**HISTORIC DISTRICT
REVIEW COMMISSION**

**HISTORIC DISTRICT REVIEW COMMISSION
Regular Meeting Agenda**

HDRC Case No. 19-004J

Application: Certificate of Appropriateness for a screened deck and solar panels
 Applicant: Trevis and Erin Martin
 Location: 415 Wilson
 District: Jewell Historic District
 NRHP Status/category: Contributing
 File Date: April 5, 2019

2 Roof

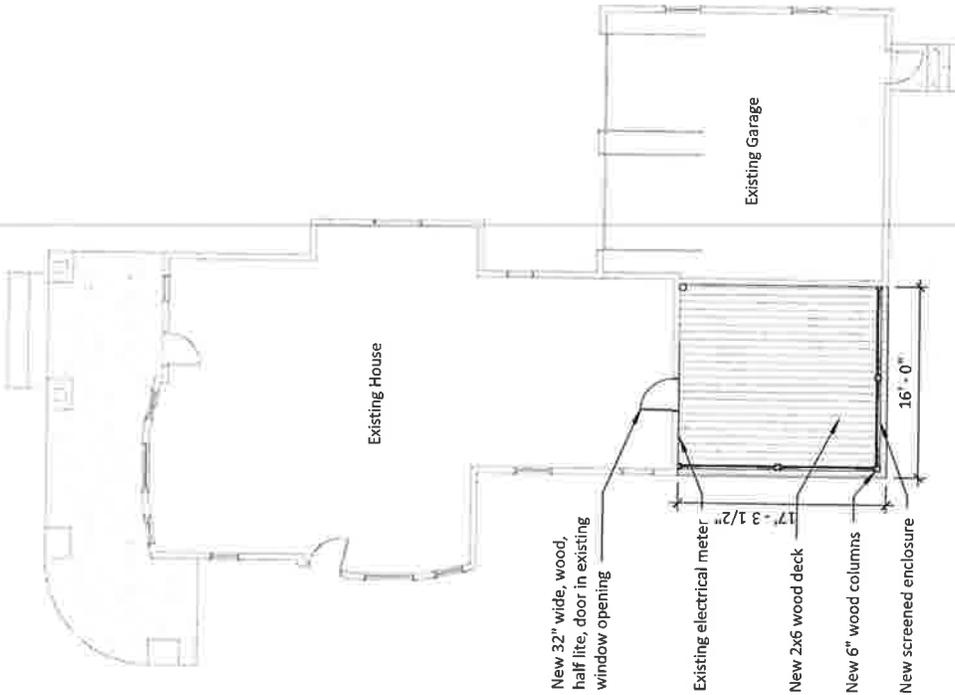
<p><i>UDO: Sec. 30-72. District HP, design principles.</i></p> <p><i>9. <u>Roofs:</u> Rooflines and shapes shall not be altered. Visible roofing materials shall be compatible with other building elements and materials in terms of color, materials, and texture. The use of roofing materials that reflect an earlier or later style or period is discouraged. Corrugated metal roofs are not appropriate for primary structures.</i></p> <p><i>Design Guidelines: Skylights and Solar Panels: Modern features such as skylights or solar panels, which were never present, are not permitted on the front façade or a visible side roof.</i></p> <p><i>Solar Panels should conform to the slope of the roof, be mounted flush with the roof and be concealed from the</i></p>	<p>Staff Analysis: Any south facing solar panels are appropriate because they are concealed from the principal views. Because the side roof is visible from the street, staff finds that the panels on the east and west side are not appropriate, unless the applicant can show otherwise.</p>

principal views. If this is not feasible for proper solar collection, consider mounting the panels on a secondary structure in the rear.

The application meets the standards for review and the historic district design guidelines; with the stipulation that the solar panels are not allowed on the east and west side, and more detail is presented on the proposed south door. With those stipulations, staff recommends approval of HDRC case #19-004J.

1 Floor 1

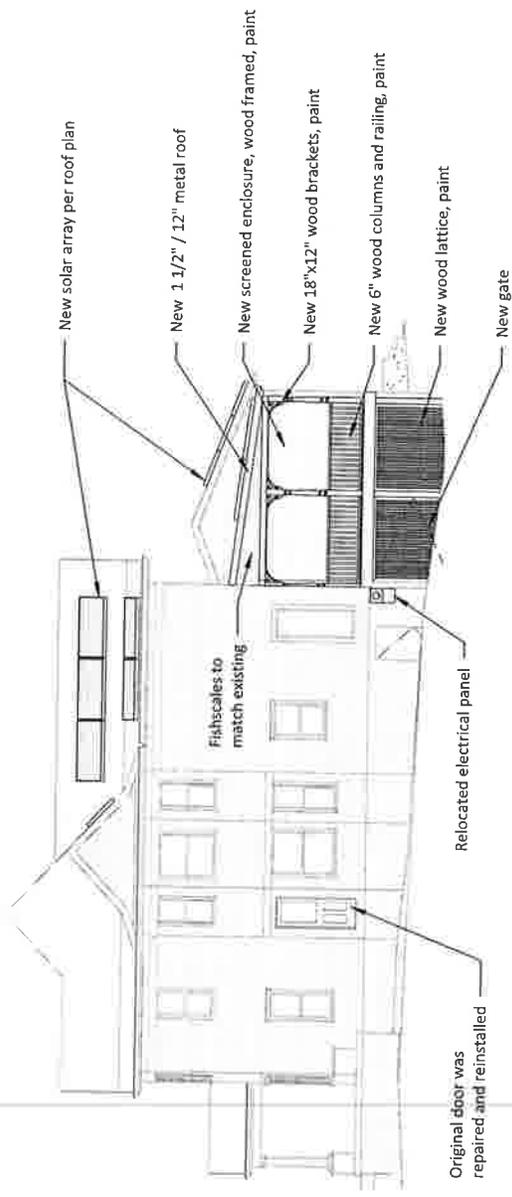
DG: Sec. 30-72. District HP, design principles.	Staff Analysis
<p><i>2. <u>Alterations:</u> Alterations shall restore a structure's original elements, materials, and appearance, if economically or physically feasible. Alterations affecting the exterior of a structure shall preserve all significant original exterior elements, including building materials, doors, windows, and decorative elements. Elements that are not original, but which may have acquired significance by virtue of age or craftsmanship, shall also be preserved.</i></p> <p><i>8. <u>Decks:</u> Decks are a late twentieth century invention and are a popular way to create an outdoor living space. They should be designed to complement the style of the house and the scale of the back of the house and the back yard.</i></p>	<p>The proposed alterations will complement the structure's original style, materials and appearance.</p>
<p><i>7. <u>Doors and windows:</u> Original doors and windows shall not be replaced unless there is substantial evidence that they are no longer serviceable or cannot be restored. Restoration of original entryways that may have been covered, altered, or removed over time is encouraged. Replacement doors and windows that imitate an earlier inappropriate style are discouraged. In general, existing openings shall not be covered or relocated. If additional entryways or service doors become necessary, they shall be located and designed in a sensitive manner. If it is necessary to expand original openings, it shall be accomplished in a manner that respects and complements the surrounding building elements, materials, and colors. On secondary elevations, the windows shall duplicate the original in size, material, general muntin and mullion detailing and glass quality.</i></p>	<p>Staff Analysis: The applicant has not selected the door for the south side leading in to the screened deck. Replacing the window opening with a door for access to the new deck would be appropriate.</p>
